RE: **Monterey Place Apts**
2306-2320 Central SW
Grading and Drainage Plan Stamp Date: none
Hydrology File: J12D030

Based on the submittal received on 9/25/19 the above-referenced Grading and Drainage Plan cannot be approved until the following corrections are made:

RE: Monterey Place Drainage Submittal for Building Permit (Hydrology File: J12D030)

SHEET TITLE
GRADING AND DRAINAGE PLAN
C-102

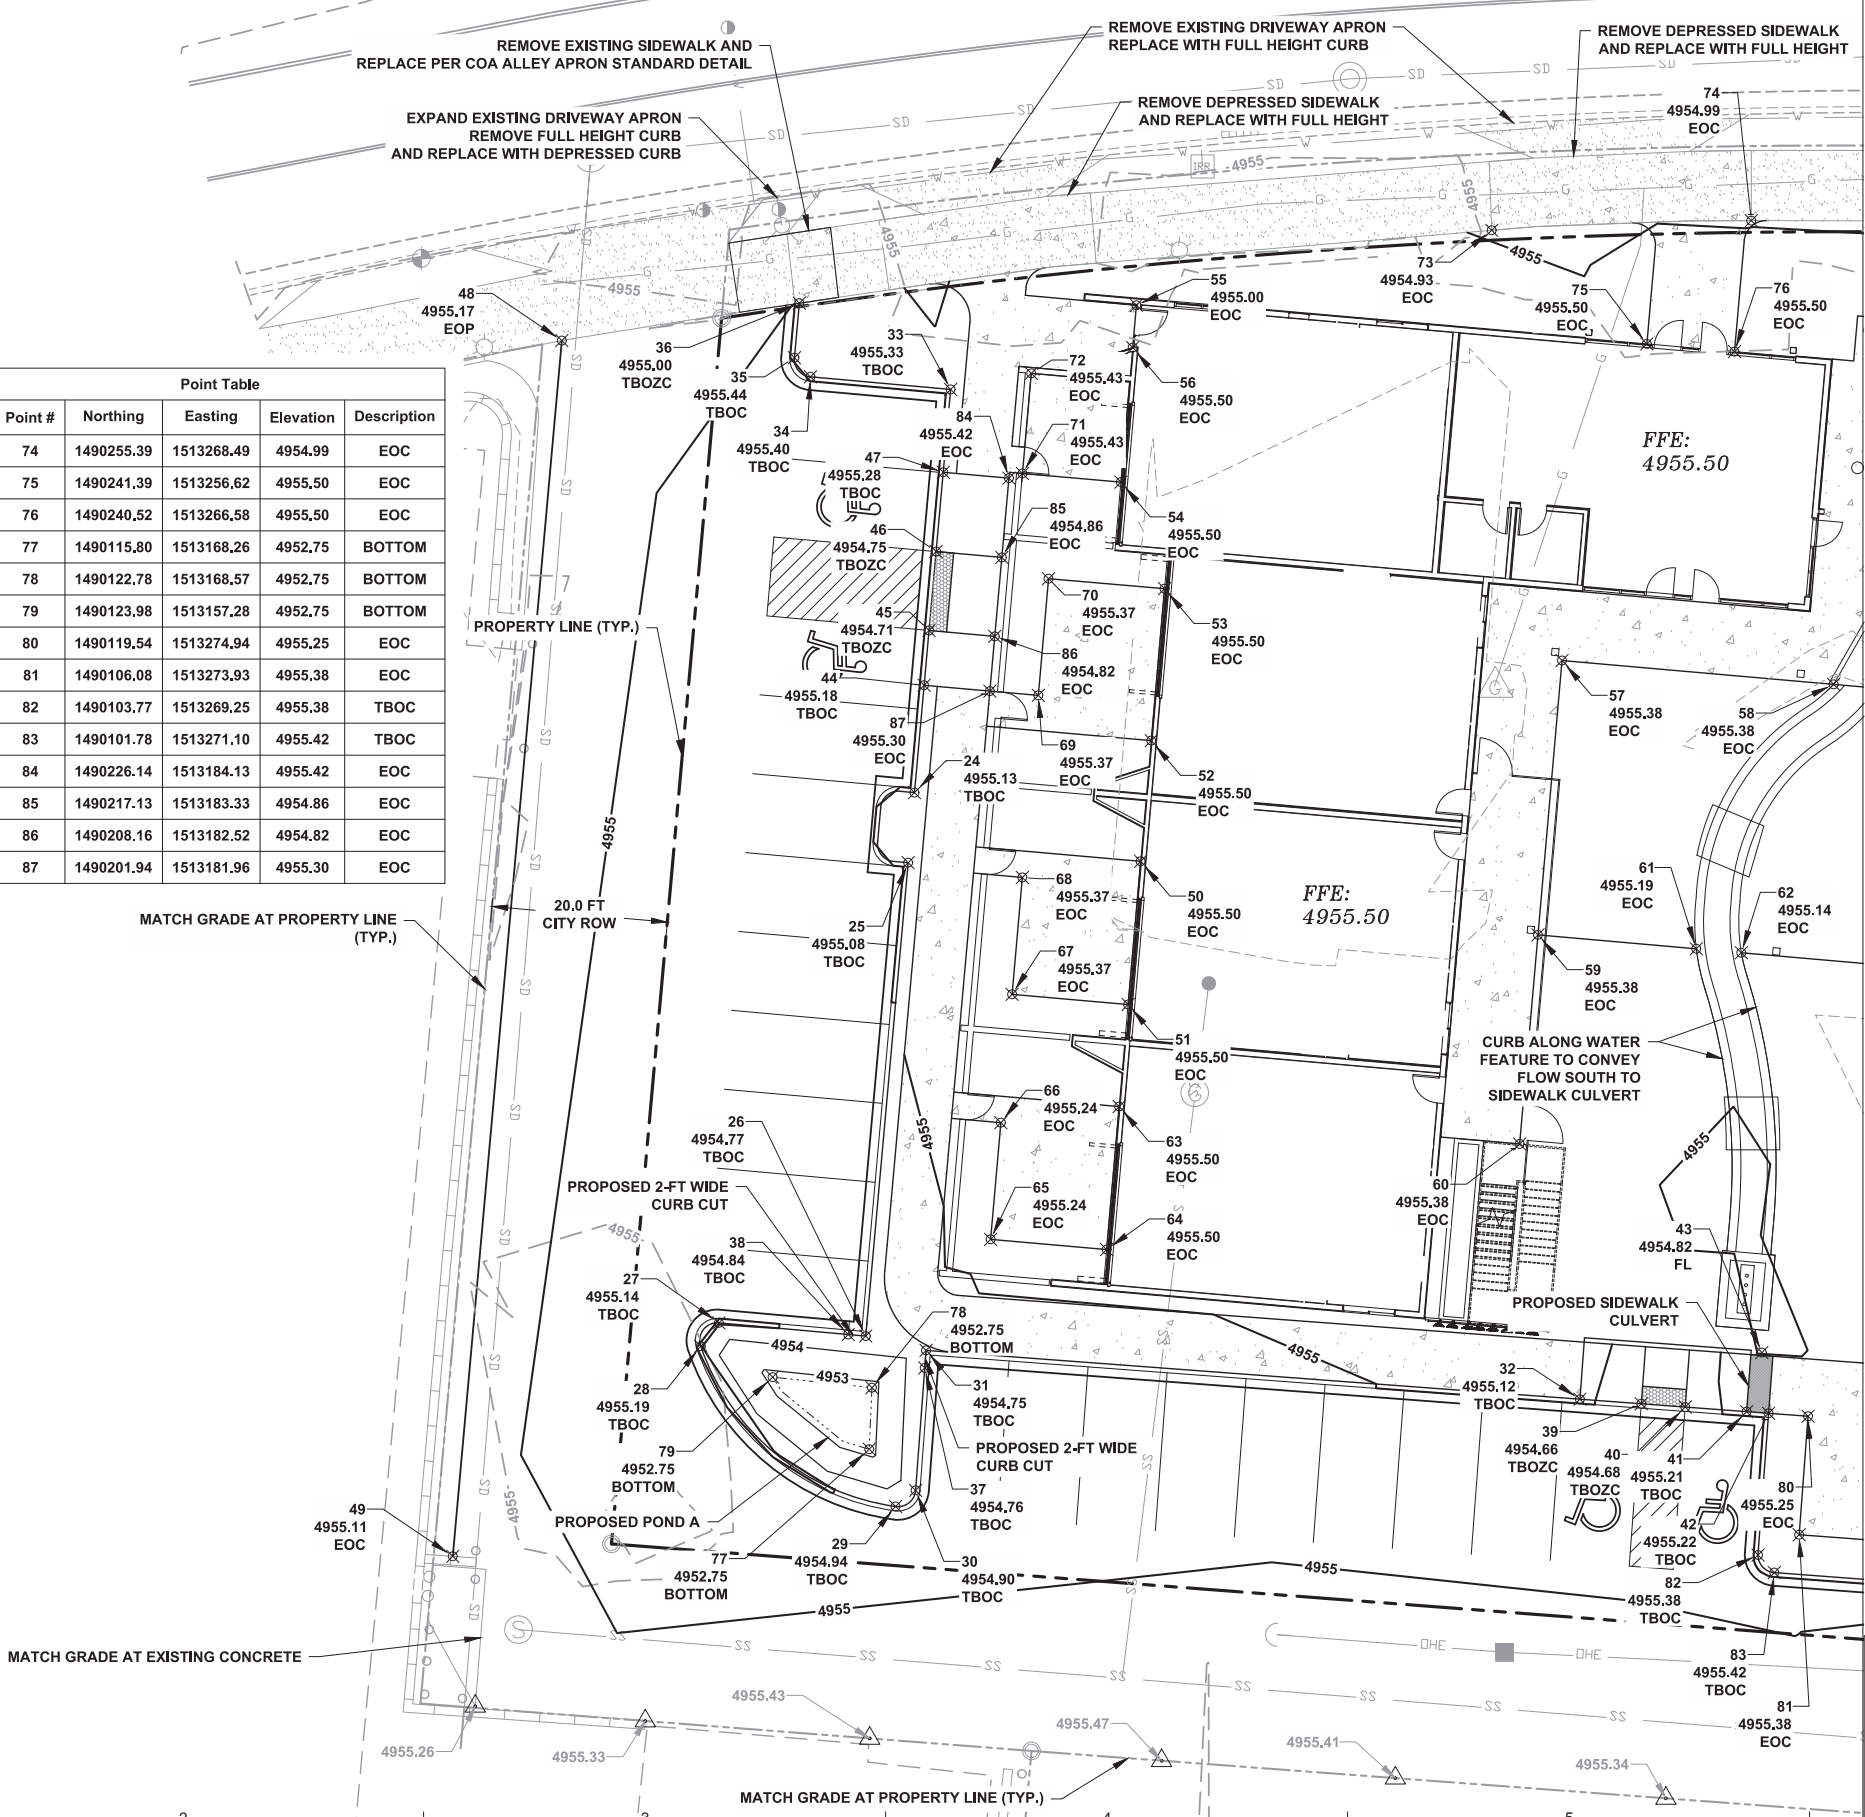
1. Remove all "Conceptual/Not for Construction" markings and stamp, sign and date the plan.
2. All drainage calculations and findings, to include those presented in the response letter, need to be provided in a bound report, stamped/signed by the engineer.
3. As a reminder, if the project total area of disturbance (including the staging area and any work within the adjacent Right-of-Way) is 1 acre or more, then an Erosion and Sediment Control (ESC) Plan and Owner's certified Notice of Intent (NOI) is required to be submitted to the Stormwater Quality Engineer (Doug Hughes, PE, jhughes@cabq.gov, 924-3420) 14 days prior to any earth disturbance.
4. Payment of the Fee in Lieu (Amount = $635\text{CF} \times \$8/\text{CF} = \5080 , per sheet C-102) of onsite management of the SWQV must be made. Include a copy of the paid receipt when resubmitting.
